**ADDENDUM 2**  
to the  
**BIDDING DOCUMENTS**  
for

**ADRIAN PHILLIPS THEATER RENOVATION**  
**Boardwalk Hall**  
**Atlantic City, NJ**

**October 19, 2017**

SCALE	DATE
AS NOTED	09/15/2017
DRAWN BY	REVIEWED BY
MJS	LYH
DRAWING NUMBER	
<b>A0.1</b>

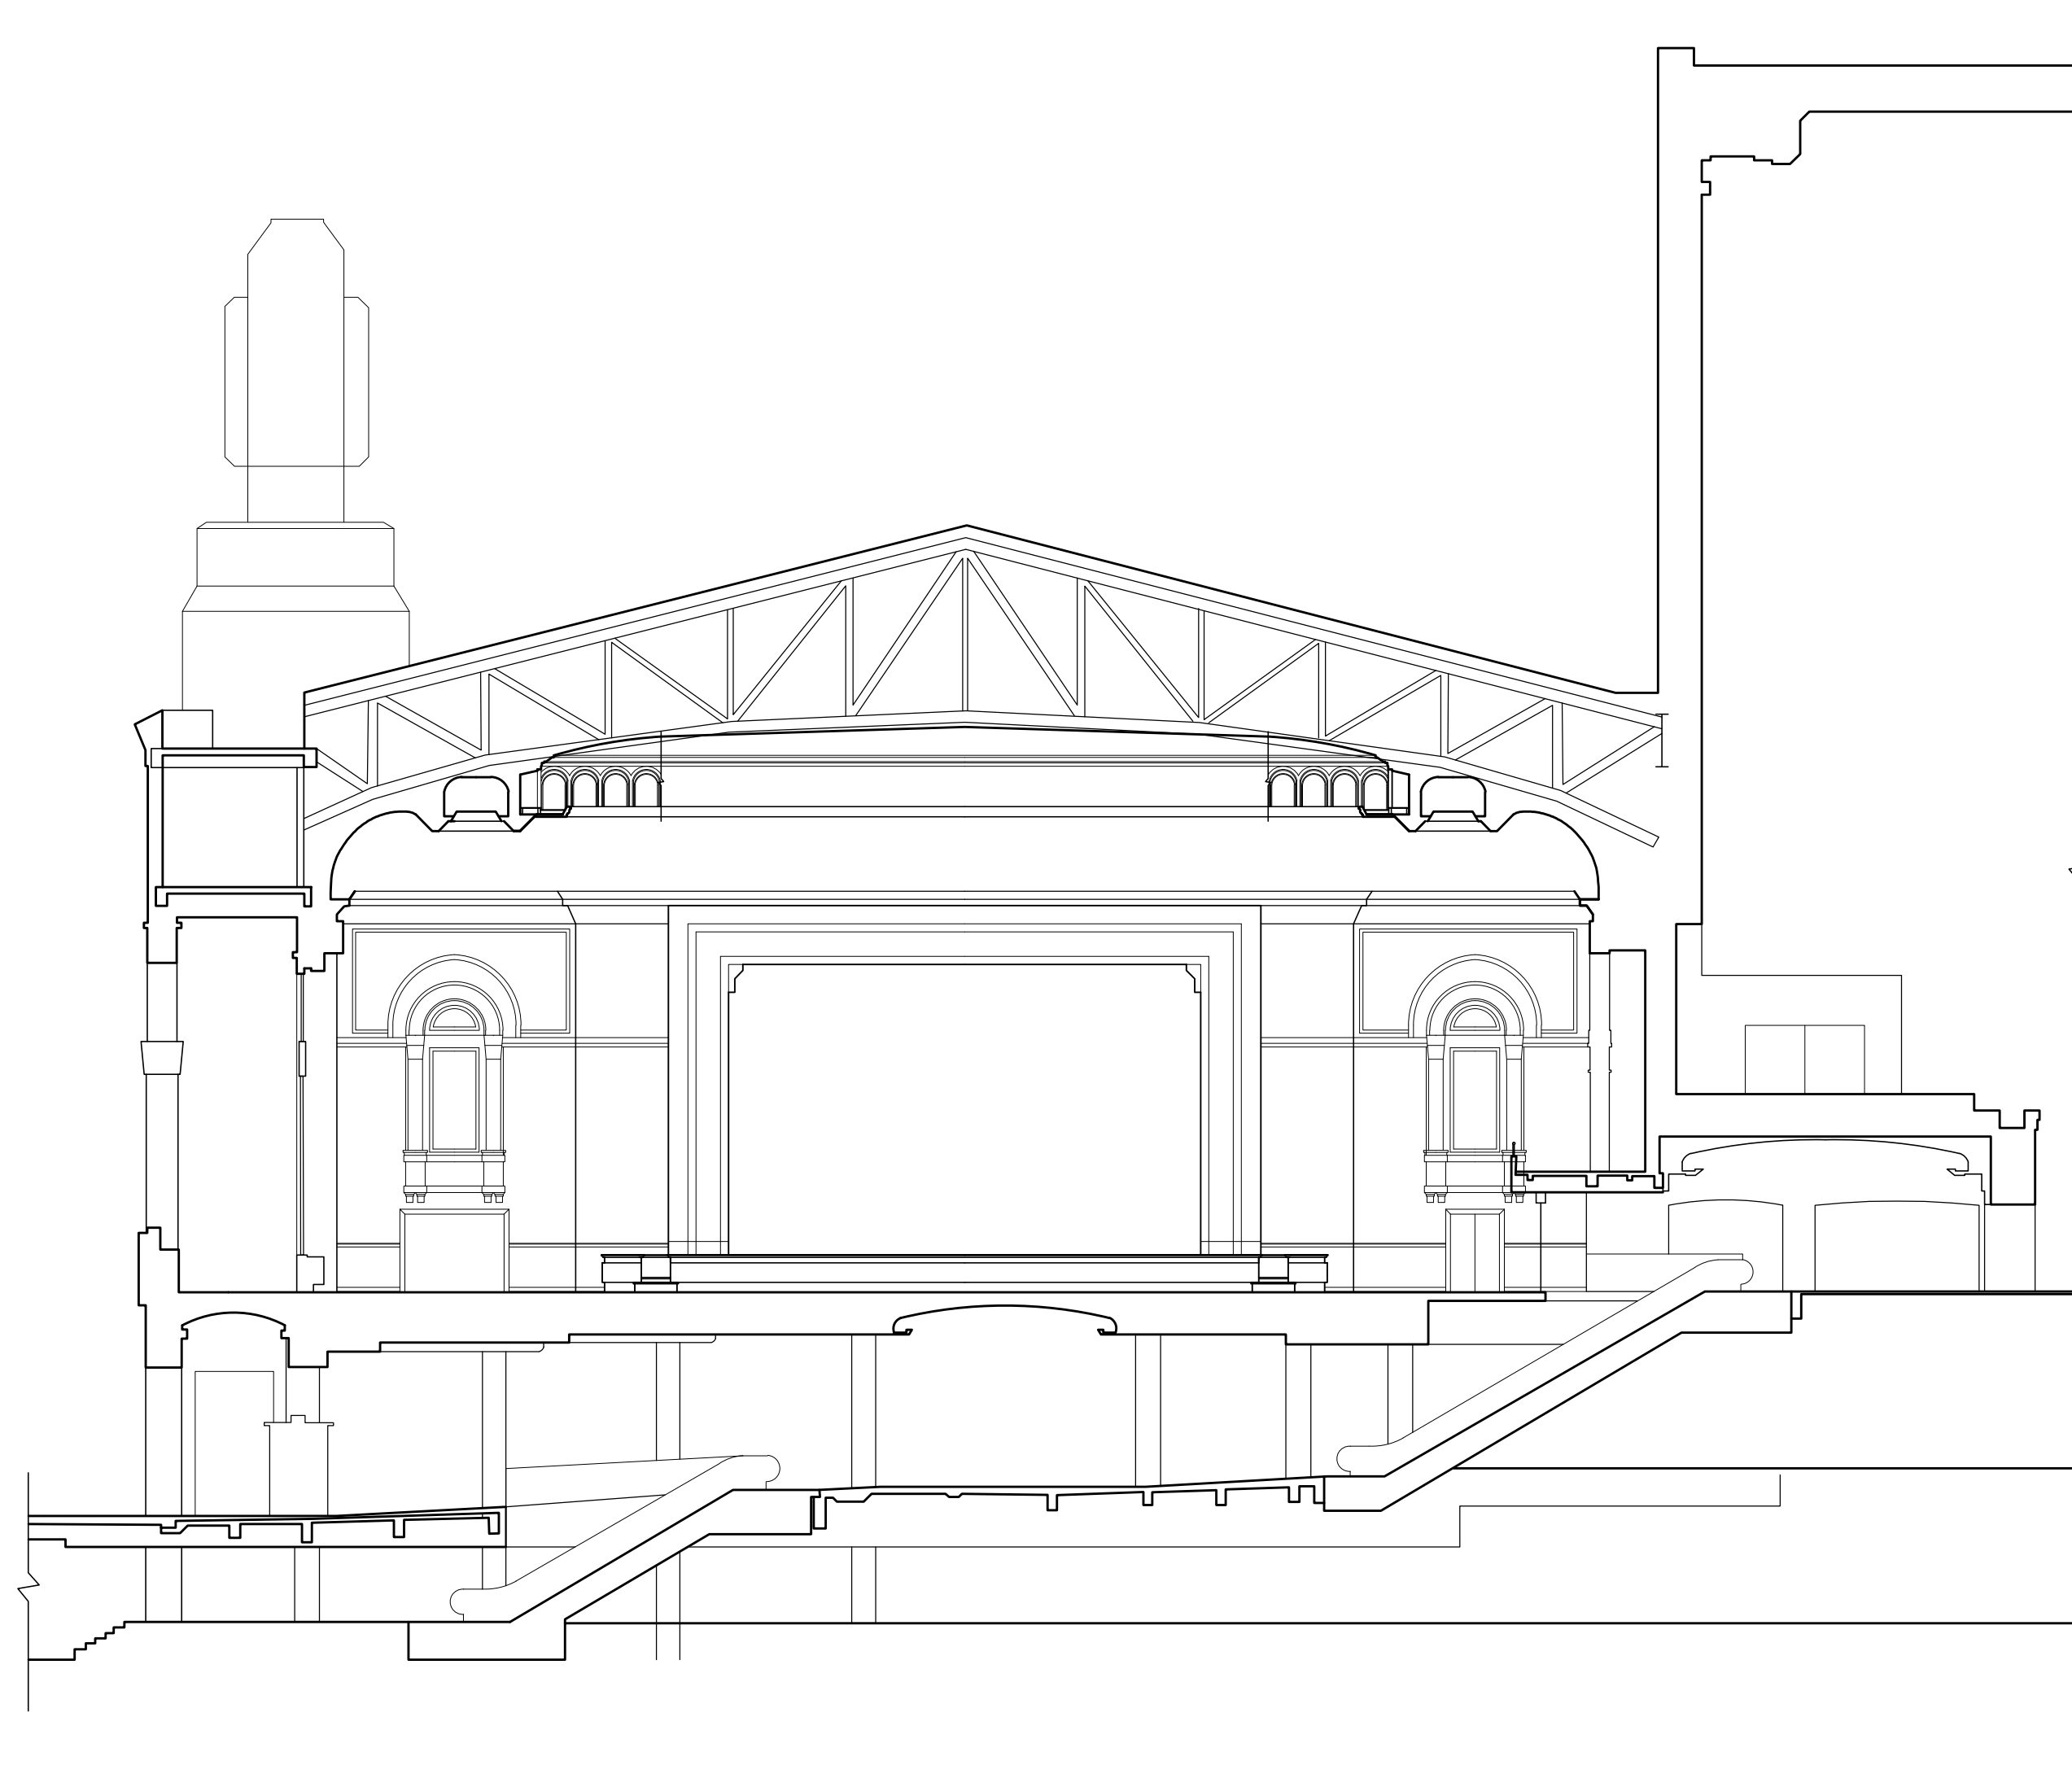
- A. Drawing A0.1: Change to Construction Notes:
  - 1. Delete item 1-C

**A0.3**

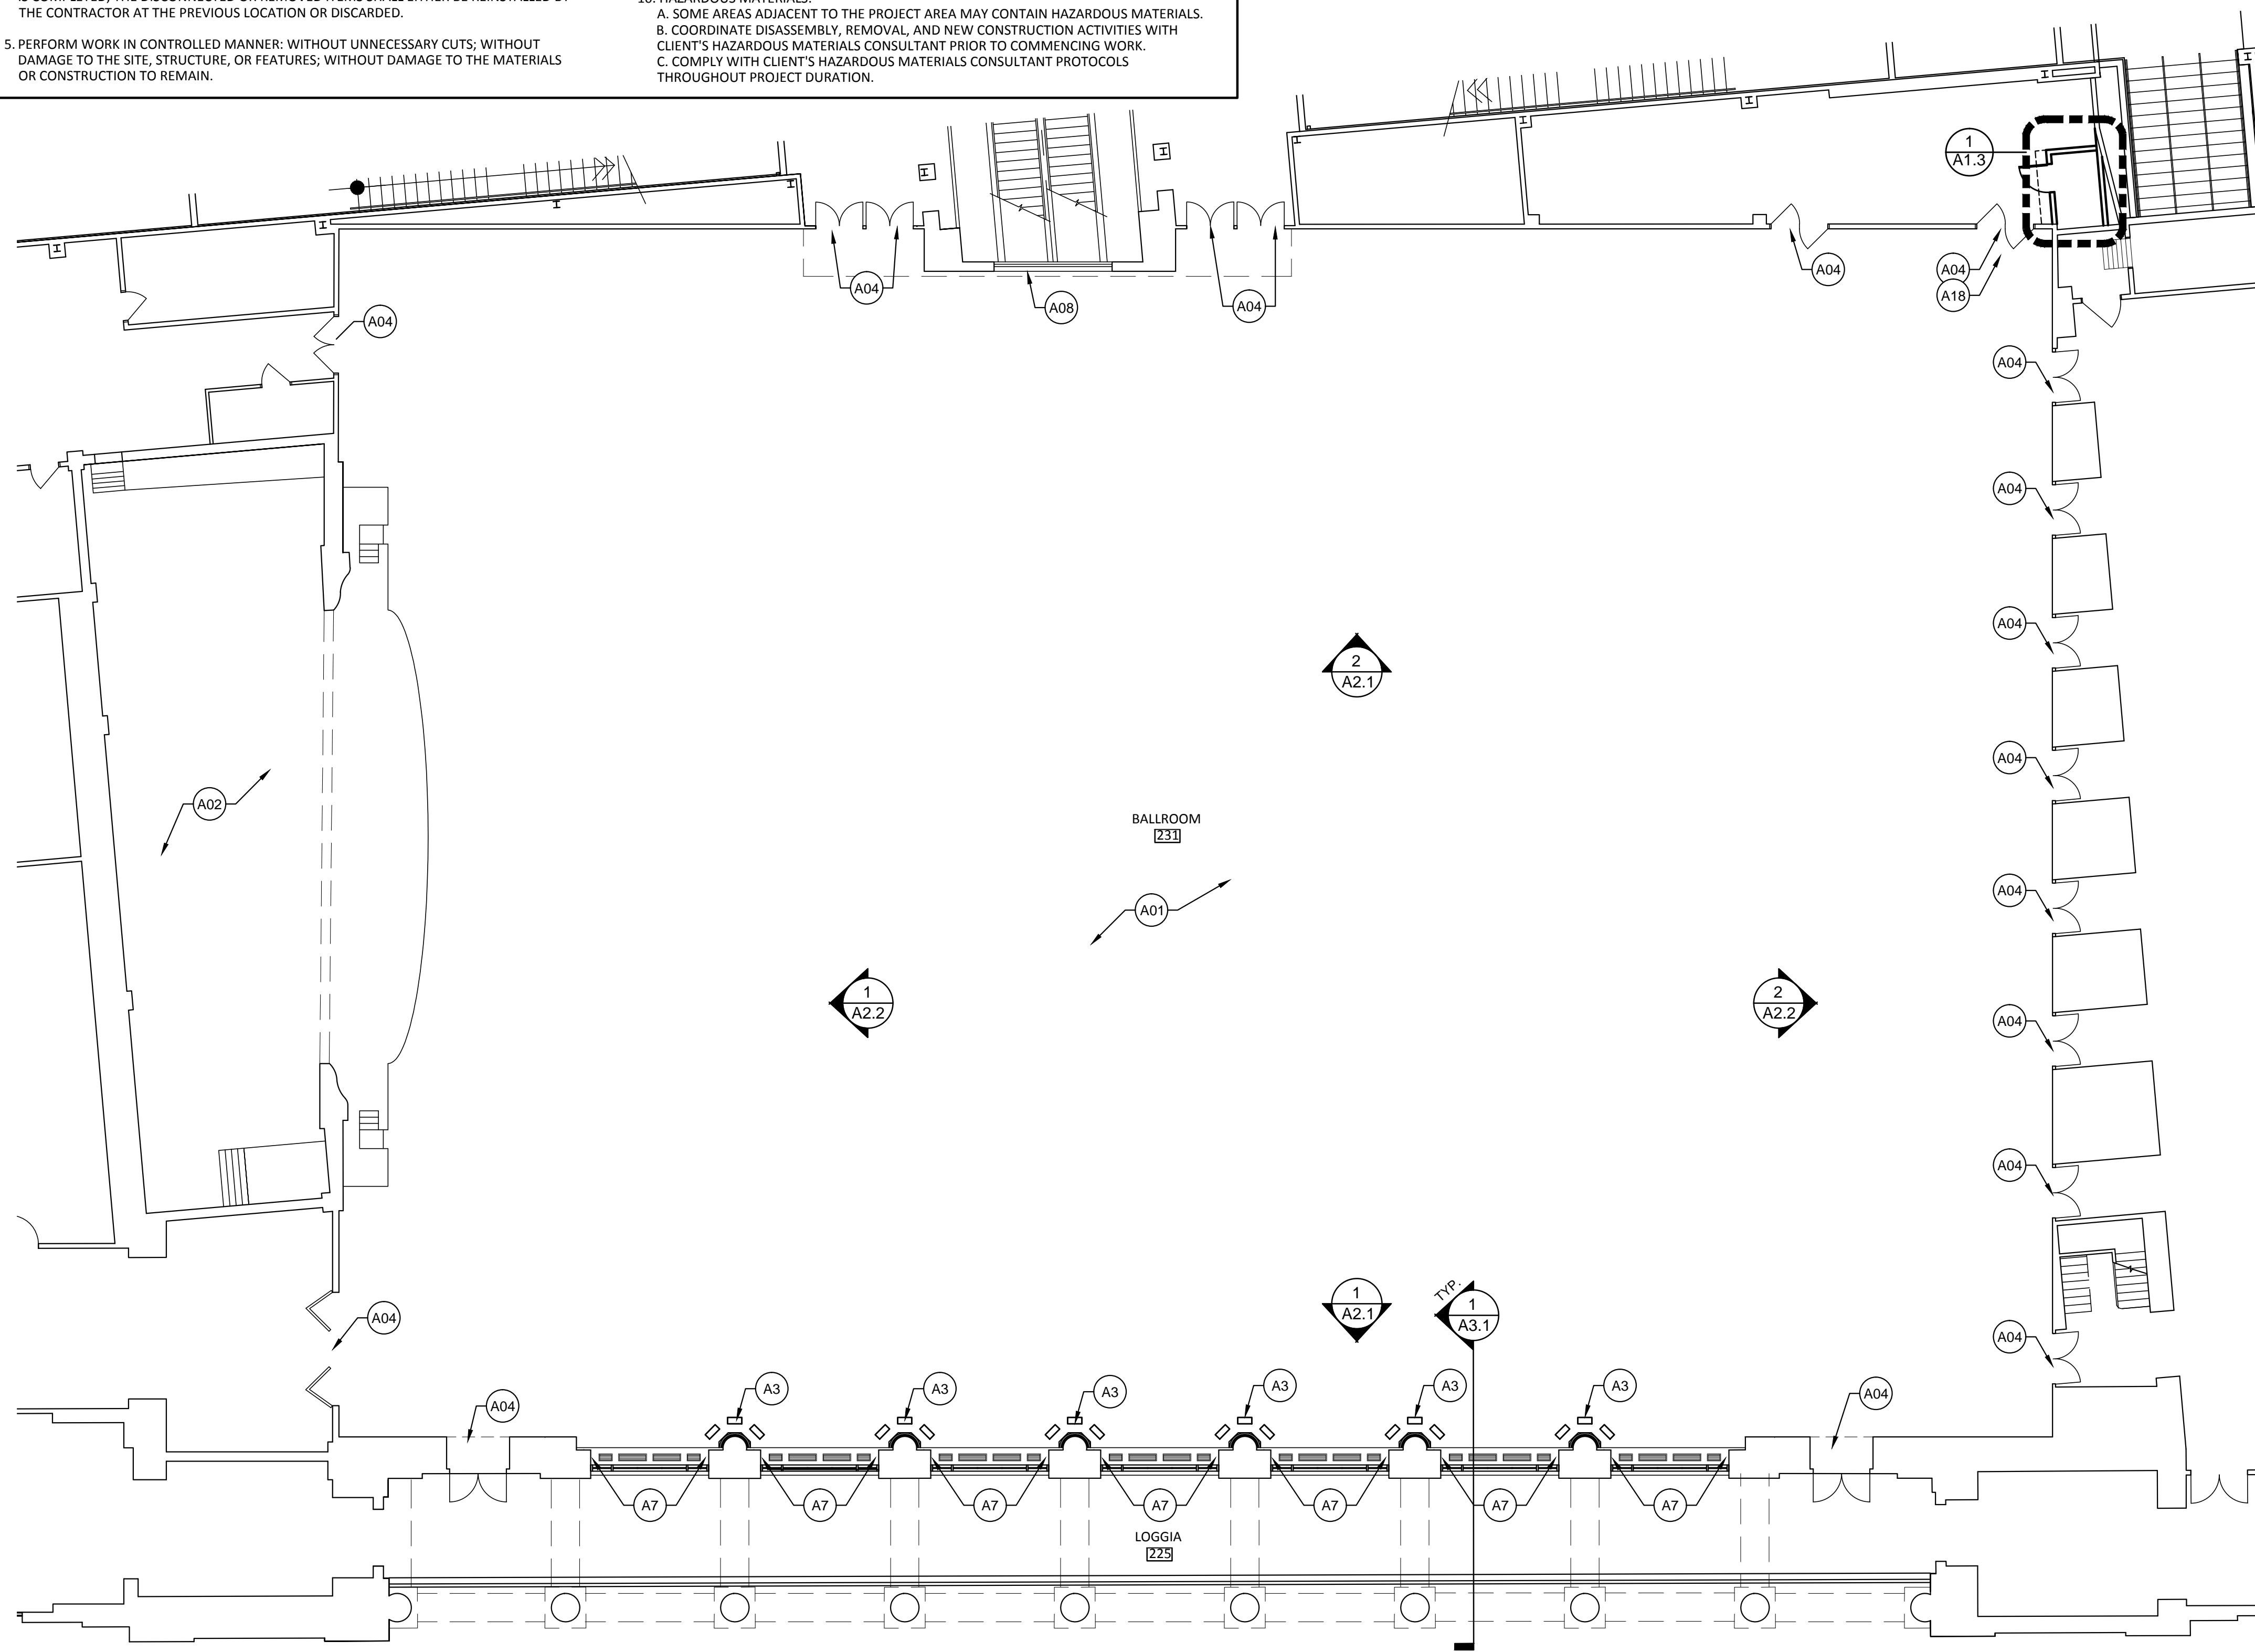
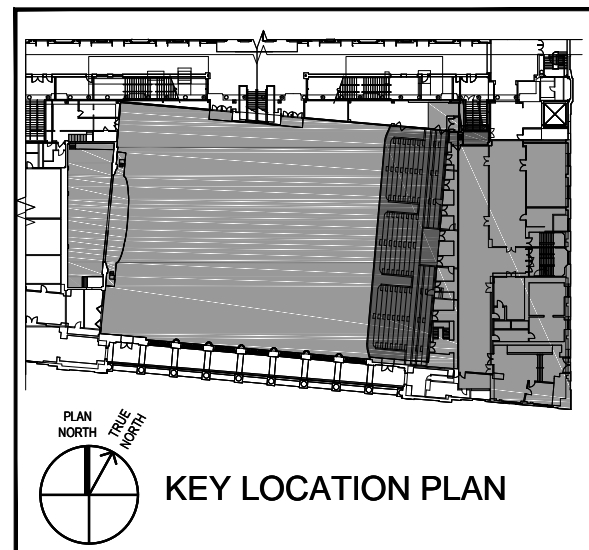
- B. Drawings A1.1, A1.2, A1.3, A1.4:
  - 1. A0.3: Scale correction
  - 2. Change to Construction Key Notes: A09-A, A14, A17, AND A21
